FINAL ENVIRONMENTAL IMPACT REPORT

Santa Cruz Wharf Master Plan

City of Santa Cruz
Economic Development

September 2020

AES-4 Lighting and Glare

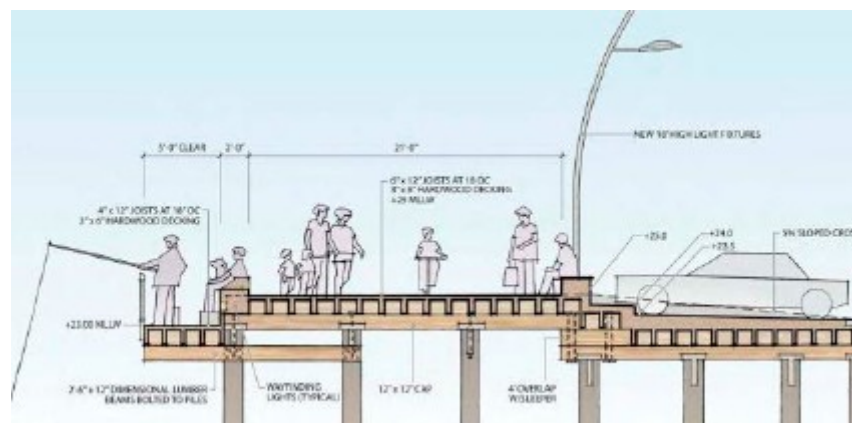
B4-5

Although we appreciate the centering of the walkway lights away from the edge of the Wharf, we are concerned about an overall increase in light due to the construction of new buildings. In order not to have impact, the overall light emitted by aspects of the design, including that emitted by the new buildings, should not increase the total light emission from the Wharf. We also note that simply not increasing the light emission may not be a high enough standard, with instead a reduction in overall light being the goal.

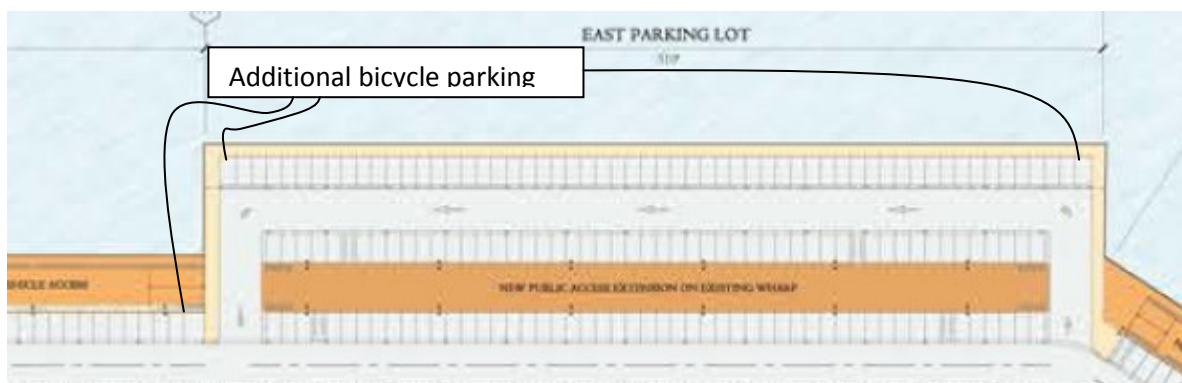
The Sierra Club appreciates and applauds the proposed design for its large bicycle and pedestrian walkway, as seen here:

This can give the impression that the Plan takes bicycle transportation seriously. Access is only a portion of visiting the Wharf by bicycle. The design fails to provide adequate bicycle parking. City of Santa Cruz Ordinance No. 2017-02 requires that public or commercial recreation uses have a number of parking spaces of at least 35% of the auto parking spaces. The design calls for 64 bicycle parking spaces yet 495 auto parking spaces – 12.9%. Although mention is made of providing more spaces in the future, how and where these spaces will be is of concern. Namely, whereas all of the auto parking spaces are designed in and indicated, the future bicycle spaces are not, and then evidently must be taken from areas already identified for pedestrian and bicycle use. A Plan without the full amount of required spaces is in conflict with the City requirements; but even if it were not the proposed 64 spaces indicates that bicycle parking is an afterthought in this Plan. We strongly recommend that all corner areas currently designated for auto parking be instead allocated for bicycle parking, so that proper accommodation of bicycles may be achieved:
